Re: Consolidated Edison Company of New York, Inc.
AEC Docket No. 50-247

The attachment supplements the document entitled, "Additional Testimony of Applicant Concerning Emergency Core Cooling System Performance", dated July 13, 1971. The attachment responds to questions raised orally by the Division of Reactor Licensing and which were discussed with the staff at a meeting on August 13, 1971.

ADDITIONAL INFORMATION ON EMERGENCY CORE COOLING ANALYSIS

FIGURE 27
.8 DE Break

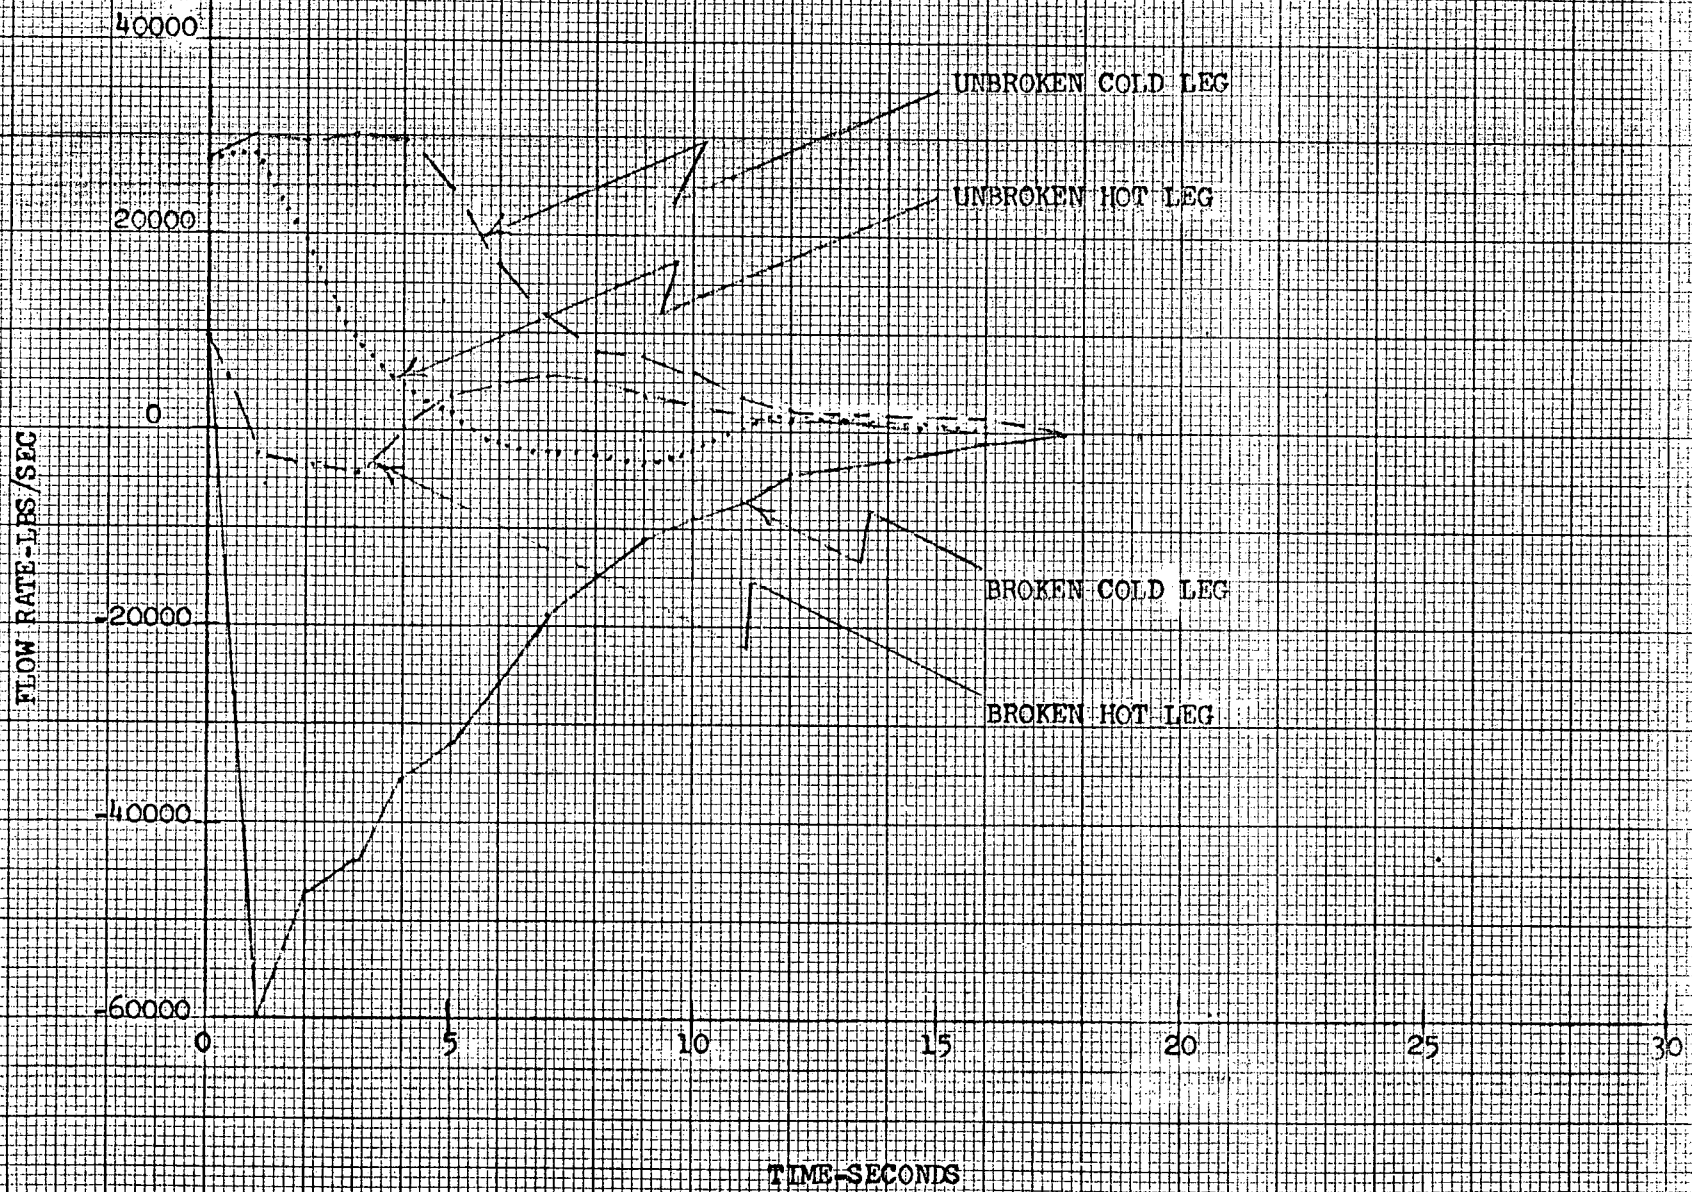
Items 1 and 2 provide additional details on the reflooding analysis and an analysis of the 0.5 square foot cold leg break. Items 3 and 4 provide clarifying information which demonstrates that the analysis in the above-mentioned document is in accordance with Appendix A, Part 3, of the Commission's interim policy statement. There is also included in the attachment a replacement for Figure 27 to correct a typographical error in identifying the broken hot leg curve.

Replacement for Fig. 27 to correct a typographical error.
